Access Compliance Report

Public Rights-of-Way

(Curb Ramps)

Intersection ID: 8802	Main Street: E_W_T_HARRIS_BV	Cross Street: ST_JOHNS_CHURCH_RD	Location: NW
ADA ID: C2721AFA465B	Ramp Type: BlendTrans1	Initial Pass/Fail: Fail	Overall Compliance: No
Severity Score: 1.25			
Codes/Mitigation Info/Possible Solution		Field Measurements/Component Compliance

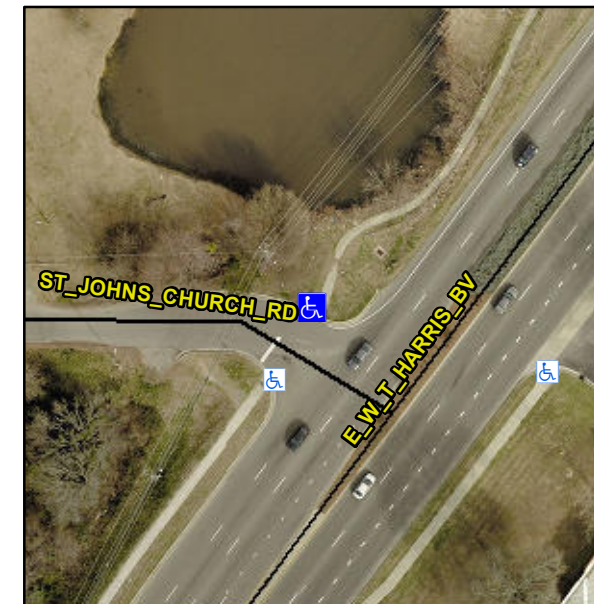
Not Found, R304.5.3

Compliance	Description	Data	Compliance	Description	Data
N/A	Ramp Length (in)	118.5	Yes	BlendTrans Slope (%)	0.9
Yes	Ramp Width (in)	72.0	No	BlendTrans XSlope (%)	3.7
N/A	Flare Type LT	N/A	N/A	Flare Type RT	N/A
N/A	Flare Slope LT (%)	N/A	N/A	Flare Slope RT (%)	N/A
N/A	Flare Traversable LT?	N/A	N/A	Flare Traversable RT?	N/A
N/A	Landing Length (in)	N/A	N/A	DWS Provided?	N/A
N/A	Landing Width (in)	N/A	N/A	DWS Contrast?	N/A
N/A	Landing Slope (%)	N/A	N/A	DWS Length (in)	N/A
N/A	Landing X Slope (%)	N/A	N/A	DWS Full Width?	N/A
N/A	Landing Curb? (Y/N)	N/A	N/A	DWS Offset (in)	N/A
N/A	Shared Landing?	N/A			
N/A	Gutter Ponding?	N/A	N/A	Gutter Slope (%)	N/A
N/A	Gutter Lip Ht (in)	N/A	N/A	Gutter X Slope (%)	N/A
N/A	Painted X Walk1?	No	N/A	Painted X Walk2?	N/A
	X Walk 1 Direction	To SW		X Walk 2 Direction	N/A
	X Walk 1 Width (in)	N/A		X Walk 2 Width (in)	N/A
	X Walk 1 Slope (%)	1.8		X Walk 2 Slope (%)	N/A
	X Walk 1 X Slope (%)	4.7		X Walk 2 X Slope (%)	N/A

N/A	Ramp inside XWalk1?	N/A	N/A	Ramp inside XWalk2?	N/A
	Road Slope (%)	4.7		Clear Space?	N/A
	Road X Slope (%)	1.8	N/A	Clear Space to XWalk (in)	N/A
N/A	Any Obstructions?	N/A	N/A	Storm Grate/Utility Hazard?	N/A
	Obstruction Type			Storm Grate/Utility Type	
		N/A			N/A
			Yes	Surface Condition? (G/P)	Good
			No	Curb Slope (%)	14.0

Remove & Replace Curb Ramp With Two New Directional Ramps or Equivalent.
